California Regional Water Quality Control Board
Santa Ana Region

STAFF REPORT

SUBJECT: Amendment to Existing Waste Discharge Requirements for County of Orange Integrated Waste Management Department, Frank R. Bowerman Landfill, Order No. R8-2002-0049

ORDER NO. R8-2002-0049

SITE PLAN

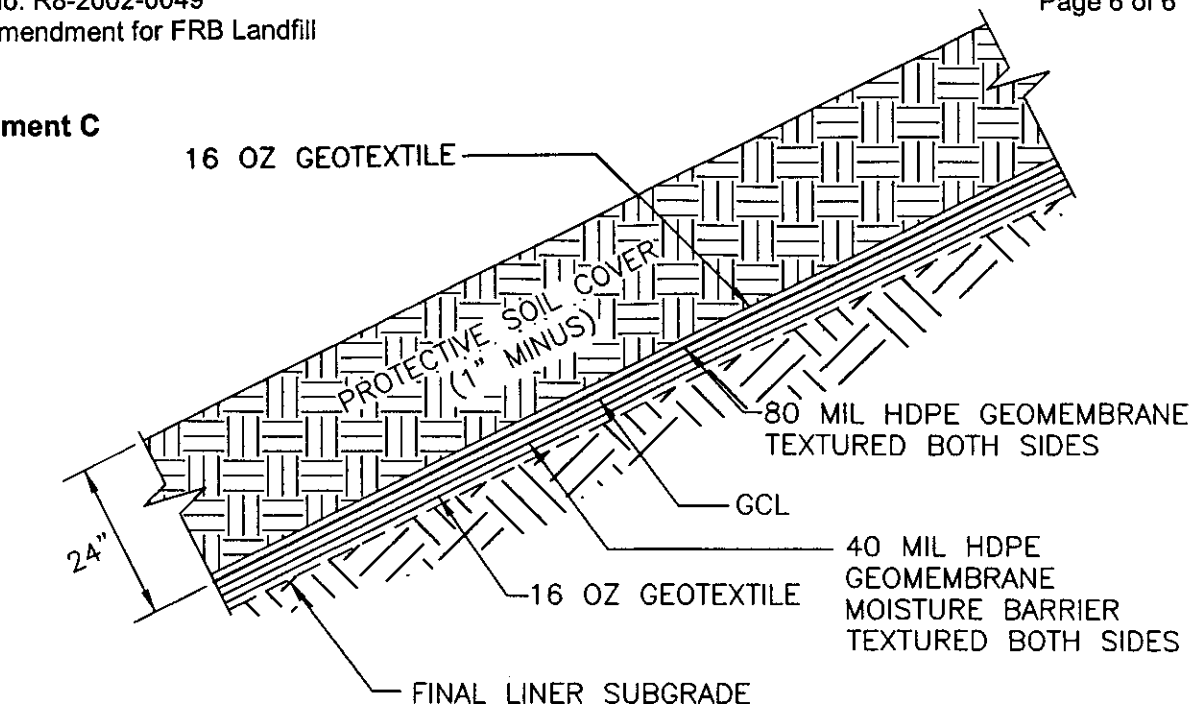
7. On September 24, 2001, the discharger submitted a Joint Technical Document (JTD), Amendment No. 2, for expansion of the permitted footprint at the FRB Landfill. The proposed lateral expansion of the landfill footprint includes Phase V-D, which is a 12-acre lined area. This lateral expansion will increase the current disposal area from 326 acres to approximately 338 acres. The Phase V-D expansion area is shown on Attachment B, which is hereby made a part of this Order.

1. The discharger shall comply with the design, construction, and Construction Quality Assurance requirements outlined in the approved JTD and any approved amendments to the JTD.
2. All landfill activities shall be limited to the 338 acres, as outlined in Attachment B of this Order.
3. The discharger shall comply with all the other terms and conditions contained in Orders No. 89-1 and 98-99.

**PHASE VD
LINER SECTIONS**

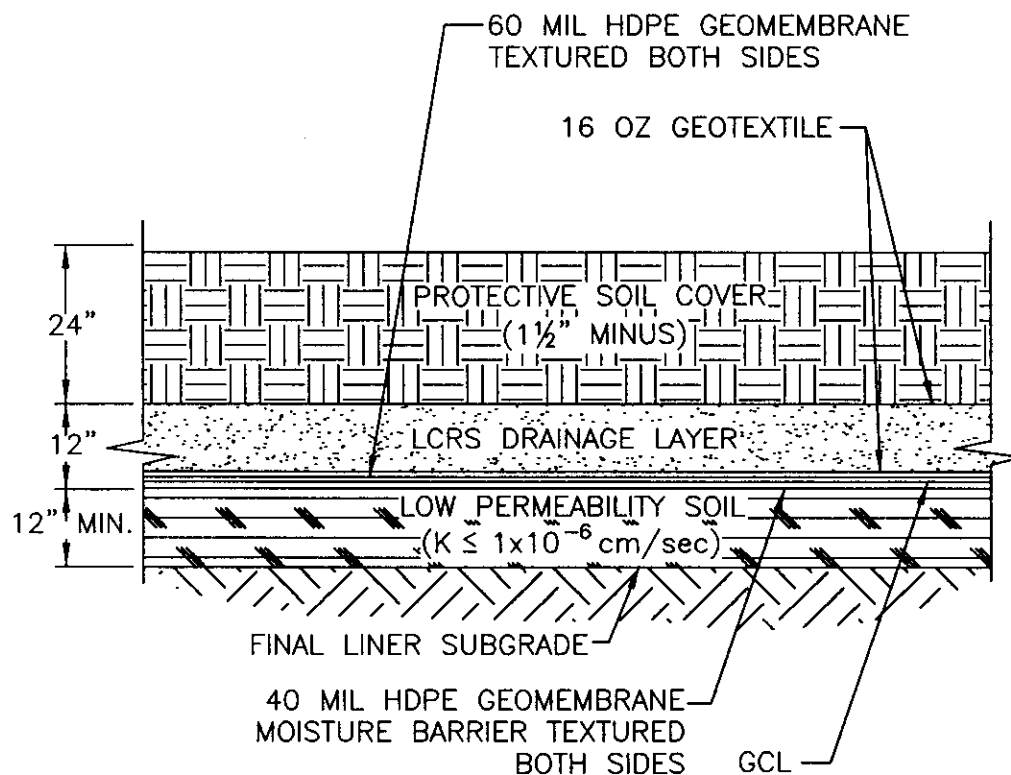
8. Phase V-D utilizes an engineered alternative design for the bottom and sideslope liner systems, shown on Attachment C, which is hereby made a part of this permit, and are described below:

- a. Bottom Liner Systems (from bottom to top)
 - Prepared subgrade
 - 12-inch $\leq 1 \times 10^{-6}$ cm/sec low permeability layer
 - 40-mil HDPE liner/moisture barrier (textured both sides)

- Geosynthetic Clay Liner (GCL)
 - 60-mil HDPE liner (textured both sides)
 - 16 oz. Geotextile
 - 12-inch LCRS Drainage Layer with a permeability of no less than 1×10^{-2} cm/sec (1/2-inch minus gravel with less than 2 percent fines)

- 16 oz. Geotextile
 - 24-inch operations layer (1.5-inch minus)
 - Refuse
 - b. Sideslope Liner Systems (from bottom to top)
 - Prepared subgrade
 - 16 oz. Geotextile

- 40-mil HDPE liner/moisture barrier (textured both sides)
 - Geosynthetic Clay Liner (GCL)
 - 80-mil HDPE liner (textured both sides)
 - 16 oz. Geotextile

- 24-inch operations layer (1-inch minus)
 - Refuse
9. Regional Board staff believes that the proposed engineered alternative liner design will afford waste containment capability equal to or exceeding that offered by the prescriptive standard liner design, provided that the Construction Quality Assurance (CQA) monitoring requirements and the other provisions specified in this order are met.
